Scientific Analysis/Calculation Administrative Change Notice

1. Document Number:	ANL-MGR-MD-000015	2. Revision:	00	3. ACN:	01
4. Title:	Data Analysis for Infiltration Modeling: Extracted Weather Station Data Used to Represent Present-Day and Potential Future Climate Conditions in the Vicinity of Yucca Mountain				
5. No. of Pages Attached:	13

Figure 6.1-53. Twelve-Year Average Daily Wind Speed for YM Sites 1, 2, and 9 (1993 through 2004), Six-and-a-Half-Year Average Daily Wind Speed for YM Sites 3 and 6 (1993 through 1998 and the first 195 days in 1999)

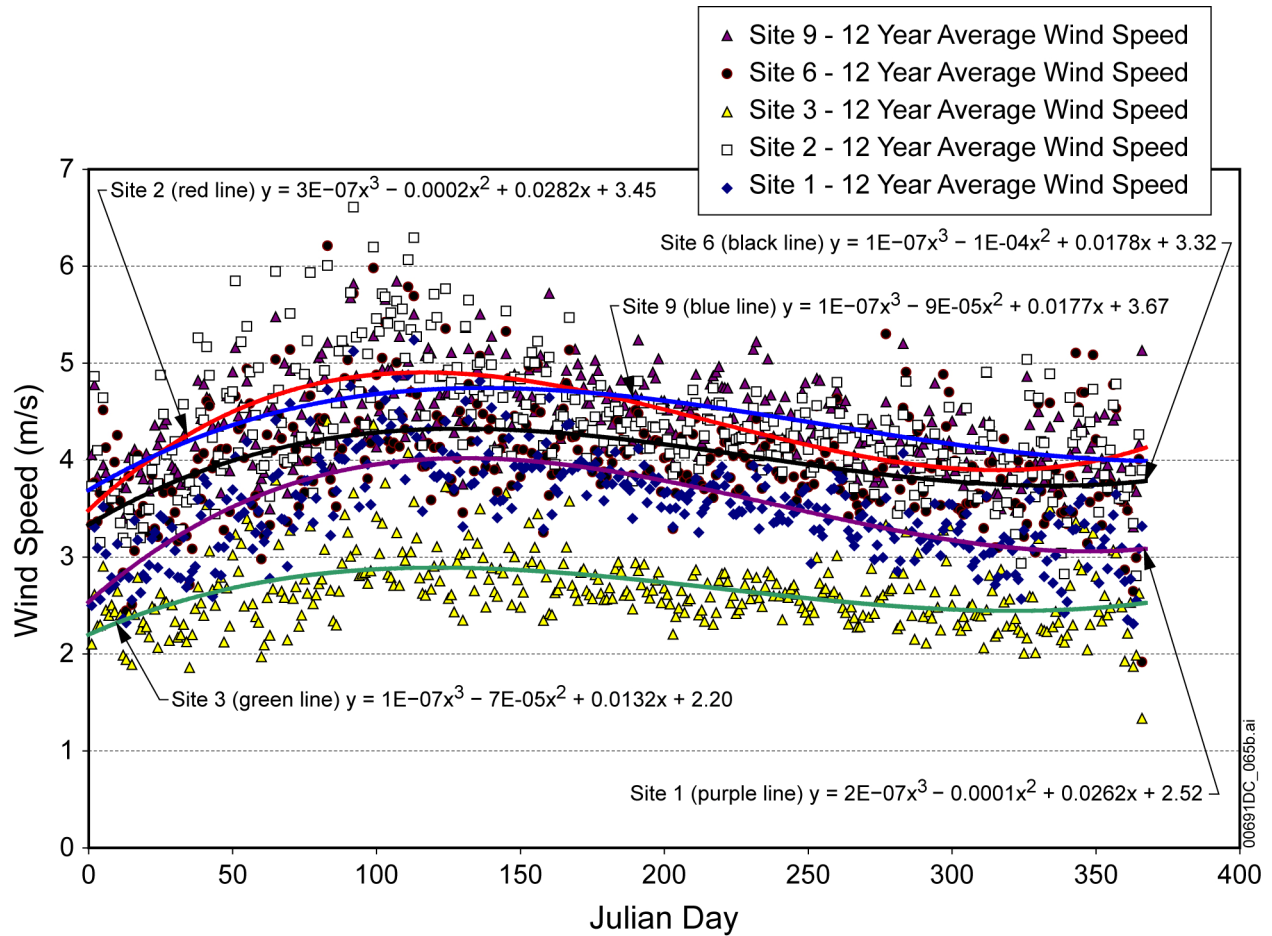
6-55	Figure 6.1-53 – incorporate DOE comment to delete the NOTE: “The trend lines shown do not distinguish between sites. The seasonal pattern occurring at all sites is discussed in Section 6.1.5.5.”
6-59	3 rd paragraph – line 8: incorporate DOE comments to change “that most frequently” to “that the most frequent” and to delete the comma between “total” and “annual”; line 9: incorporate DOE comment to insert “amount” after “precipitation.”
6-72	Figure 6.2-22 – incorporate DOE comment to insert “NOTE: Median regression line (lower line), average regression line (upper line).”
